SUBMISSION ON THE PROPOSED REPLACEMENT CHRISTCHURCH DISTRICT PLAN

SUBMITTER NAME: Milns Road Farm Limited and Blakesfield Limited

Appendix 8.6.4 North Halswell Outline Development Plan

Attachment 1 – Amendment sought to ODP

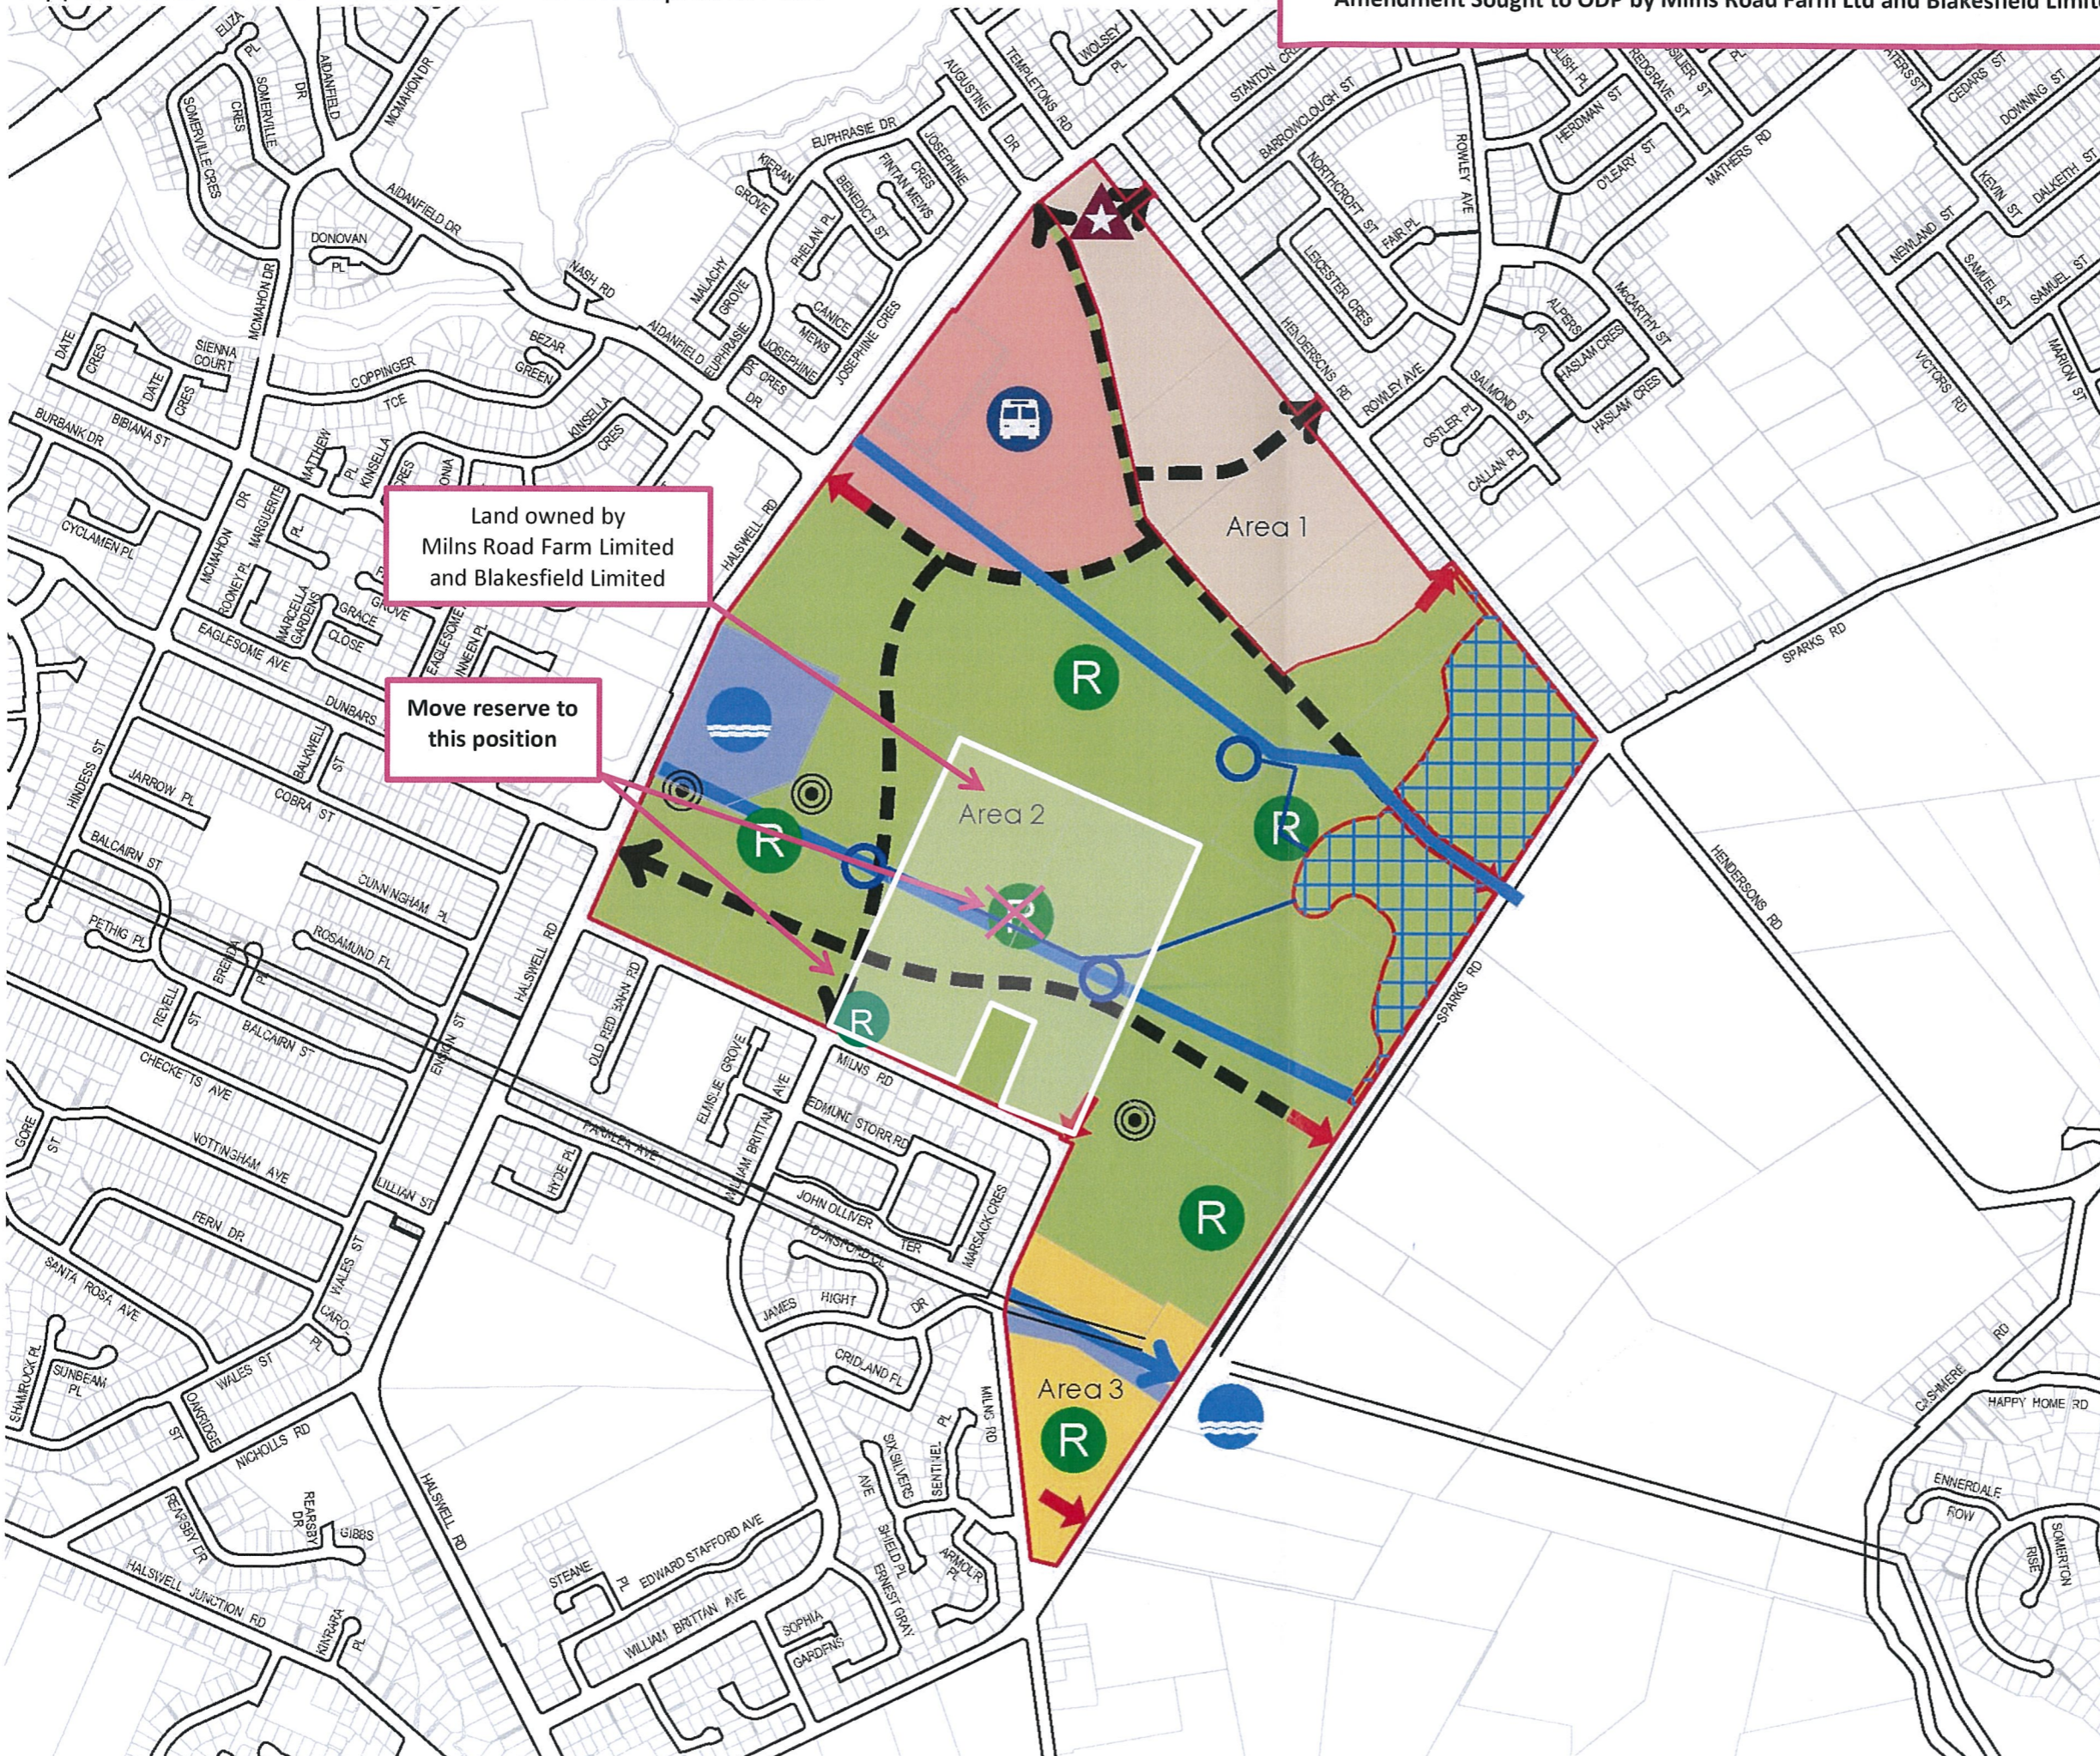
Whilst we generally support the ODP for North Halswell, we consider the provision of reserves within the ODP should not be restricted to the general areas where they are shown. The provision of a recreational route along the upgraded waterways is appropriate, but it is not necessary to then require the establishment of the local reserve within the same locality. As such it is considered appropriate to relocate the reserve shown on the submitter's land to a position away from the water way. The position considered most appropriate is to the southeast of the proposed collector road that intersects with William Brittan Drive.

1. That the ODP for North Halswell is amended by shifting the reserve shown on the submitters' land to a position as shown in Attachment 1.
